On behalf of the Philadelphia Water Department (PWD), I wanted to thank you and your colleagues at the PADEP for taking the time to meet with us on June 14 to discuss your comments submitted June 6, 2012 on our Implementation and Adaptive Management Plan (IAMP) submittal.

David Burke's Comments

Response to DEP IAMP Comments – Appendix A
Office of Watersheds - PWD
July, 2012

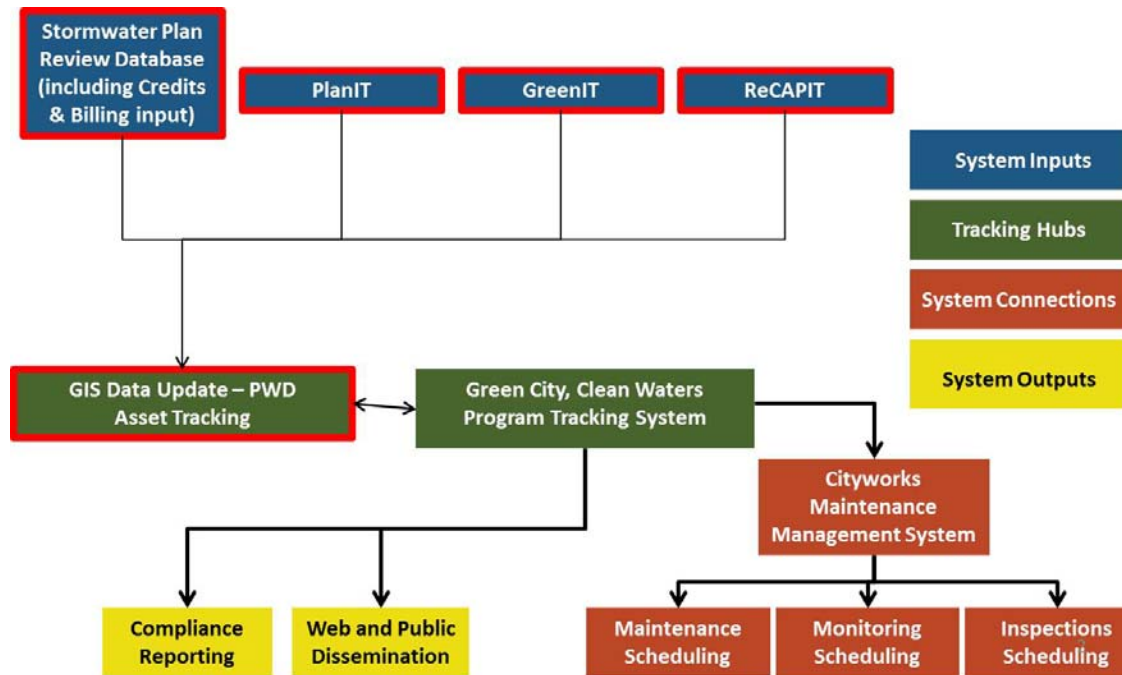
1. **Section 2.1.1 (“Tracking System Development”)** contains a brief discussion of the Interim Tracking System and the Green City Clean Waters Program Tracking System (“GCCW System”). DEP requests that the City provide a more detailed schedule for the completion and implementation of the GCCW System. The language in this section implies that the system may not be completed until the fifth year of the program, and this implied time frame gives DEP some concern. We request Philadelphia Water Department’s (“PWD”) explanation of why this task is extended over such a long time, as well as a discussion of how PWD intends to handle the transition from using the Interim Tracking System to using the GCCW System.

As described in the IAMP, the Water Department already has a number of robust data tracking systems in place and being utilized. What is planned is the integration of these existing data tracking systems through the creation of a *Green City, Clean Waters* Program Tracking System “hub” as a means of simplifying the compilation of information from these various systems for improved information dissemination and regulatory reporting. On page 2-2 of the IAMP, the following figure illustrated PWD’s vision for linking project tracking information.

In the months since the IAMP was submitted, PWD initiated updates to some of these systems to enhance their ability to track data and prepare for the development of the Green City, Clean Waters “hub”. This has resulted in an evolved graphical representation of PWD’s vision for the master
